# Blessington Greenway

Quality Audit (including Stage 1 RSA)

Project number: 60617025  
Doc Ref:60617025-QA1

January 2024

Figure 7-3 – Visibility to Greenway R758 Crossing Point

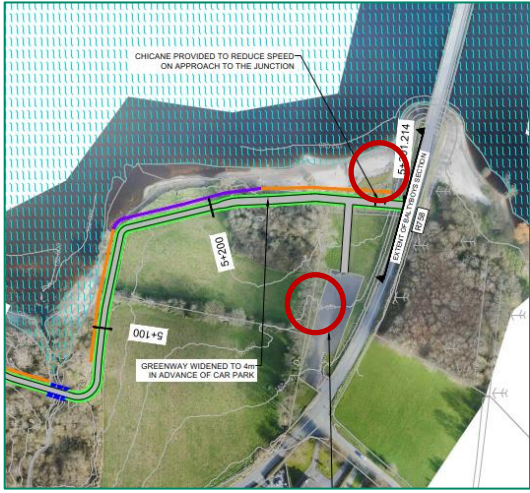
<b>7.2.3. Problem</b>		
<i>Location:</i>	Baltyboys Section connection to the Tulfarris Loop	
<i>Drawing:</i>	60617025_SHT_DD_BLGWY_142 Baltyboys Sheet 8 of 8	
<i>Summary:</i>	Restricted visibility to crossing connection	
<b>Description:</b>		
<p>The connection between the Baltyboys and the Tulfarris schemes is proposed at the junction of the R758 and the local L8360 road. The R758 is posted as an 80km/h speed limit but vehicle speeds at this location. High through speeds on the R758 at this location might lead to vehicle users not observing cyclists crossing at this location which may result in the vehicle unable to stop in time and can lead to NMU/vehicular collisions.</p>		
<b>Recommendation:</b>		
<p>Ensure sufficient forward visibility and signage is provided on the R758 and L8360 road to indicate the presence of the cycle access and potential for NMUs crossing the R758.</p>

Figure 7-8 – Shared Use Signage

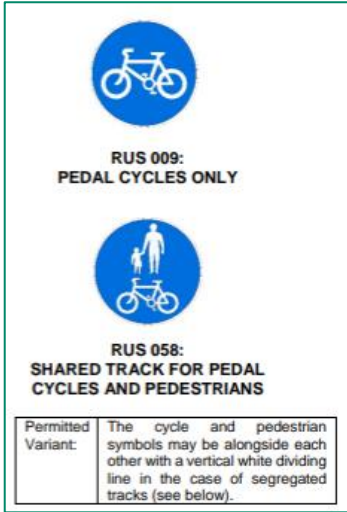
7.3.1. Problem		
Location:	Scheme wide	
Drawings:	60617025_SHT_DD_BLGWY_142 series	
Summary:	Shared use Signage	
<b>Description:</b>		
<p>There is a lack of proposed signage indicated along the route and at the linkage connection points to indicate to either drivers, pedestrians, or cyclists the presence of the shared Greenway. The lack of the appropriate signage on the route will not inform the users of the shared area, which might cause confusion and lead to pedestrian and cyclist collisions.</p>		
<b>Recommendation:</b>		
<p>Provide appropriate shared use signage on all proposed linkages to existing facilities, to indicate the shared and segregated pedestrian and cycle facilities on approach to / from the Greenway.</p>

**Problem 7.2.1**

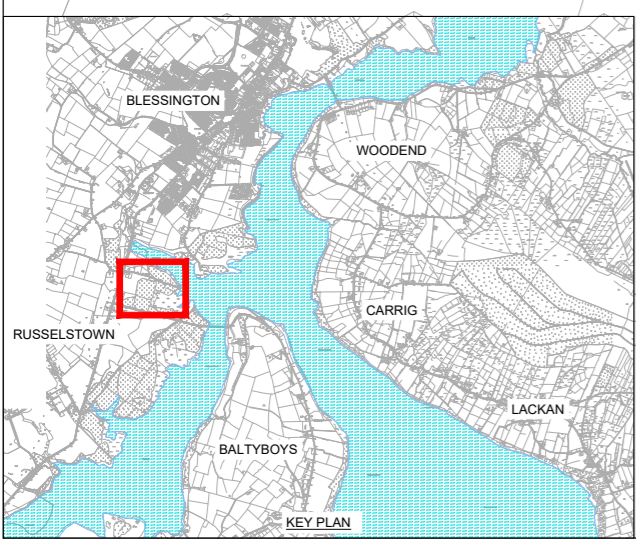
<b>7.2.1. Problem</b>		
<b>Location:</b>	Burgage Moyle Road – Chainage 5+000	
<b>Drawing:</b>	60617025_SHT_DD_BLGWY_142-Blessington Sheet 6 of 11	
<b>Summary:</b>	Unsuitable road surface	
<b>Description:</b>		
<p>During site inspection it was observed that the local road, Burgage Moyle Road, is potholed and extremely uneven which is unsuitable for many forms of cycles. As Greenway users will be directed to use this road as a connection link, the lack of proper road surface may lead to cyclists avoiding this road and bypassing this section by travelling on the section of N81, where there is no footpath provision, to link back into the Greenway. This can lead to cyclists cycling on the national secondary road where the posted speed limit is 100km/h which could result in cycle/vehicle collisions.</p>		
<b>Recommendation:</b>		
Upgrade the surface of the Burgage Moyle Road to a standard to accommodate all non-motorised users.

**SHEET TITLE**  
 PRELIMINARY DESIGN  
 BLESSINGTON  
 SHEET 10 OF 11

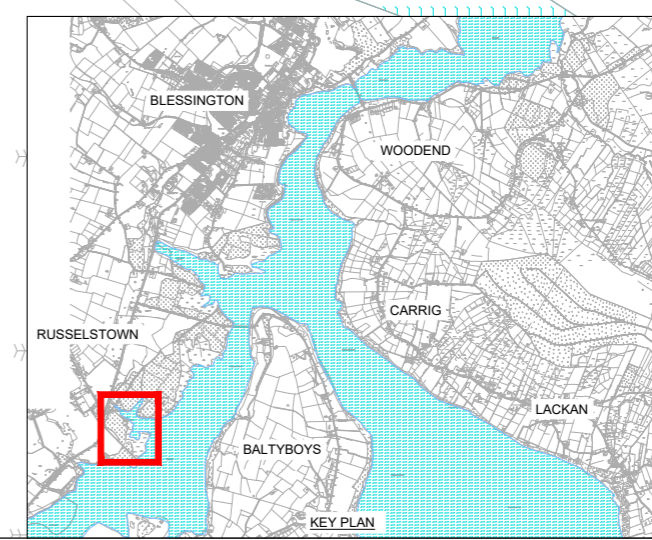
<b>7.4.3. Problem</b>		
<b>Location:</b>	Russelstown Carpark	
<b>Drawing:</b>	60617025_SHT_DD_BLGWY_142-Blessington Sheet 10 of 11	
<b>Summary:</b>	Vehicular Barriers restrict cyclists	
<b>Description:</b>

**PROJECT NUMBER**  
 60617025  
**SHEET TITLE**  
 PRELIMINARY DESIGN  
 BLESSINGTON  
 SHEET 11 OF 11  
**SHEET NUMBER**  
 60617025\_SHT\_DD\_BLGWY\_142.11

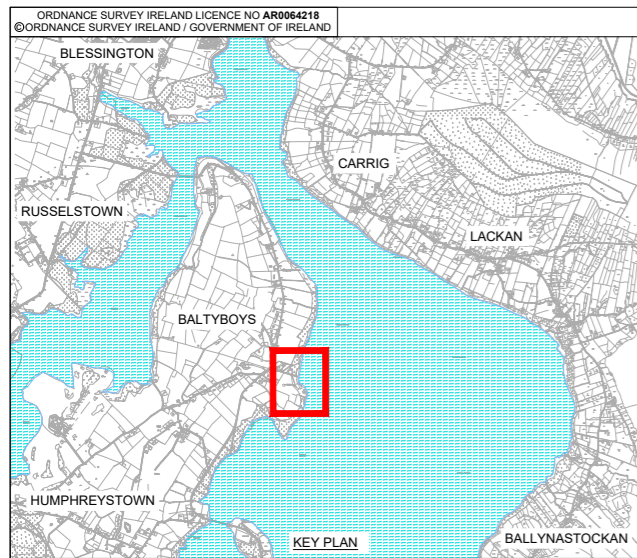
<b>7.4.4. Problem</b>		
<b>Location:</b>	N81 – Connection with Russborough House & Park	
<b>Drawing:</b>	60617025_SHT_DD_BLGWY_142-Blessington Sheet 11 of 11	
<b>Summary:</b>	Restricted Headroom at tunnel	
<b>Description:</b>

**SHEET TITLE**  
PRELIMINARY DESIGN  
TULFARRIS  
SHEET 4 OF 4

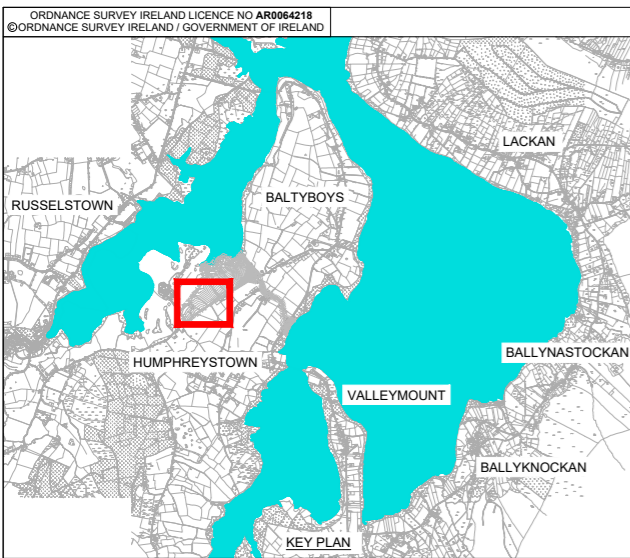
<b>7.2.6. Problem</b>	
<b>Location:</b>	Tulfarris Hotel & Golf Resort
<b>Drawing:</b>	60617025_SHT_DD_BLGWY_142.4 Tulfarris Sheet 4 of 4
<b>Summary:</b>	Crossing private lands
<b>Description:</b>

<p>Figure 7-6 - Maintenance Yard Entrance</p>	
<p>It is indicated that the proposed Greenway is to cross diagonally through the maintenance yard of the Tulfarris Hotel &amp; Golf Resort. It is unclear to the auditors how this arrangement will be formed. There is the potential for interaction with agricultural and maintenance vehicles through this yard which could lead to non-motorised user collisions.</p> <p>The connection between the offline section to the on-road section of the loop, will connect at the Tulfarris House Hotel, the offline section is proposed to cross the exciting maintenance vehicles access road, on chainage 2+400. As this road will be mainly used by maintenance vehicles the crossing at this point will be unexpected by drivers, which might cause cyclist collision.</p>	
<b>Recommendation:</b>	
<p>Revise the route through this yard to minimise the crossing distance and provide defined access locations or relocate the Greenway route around the maintenance yard.</p>
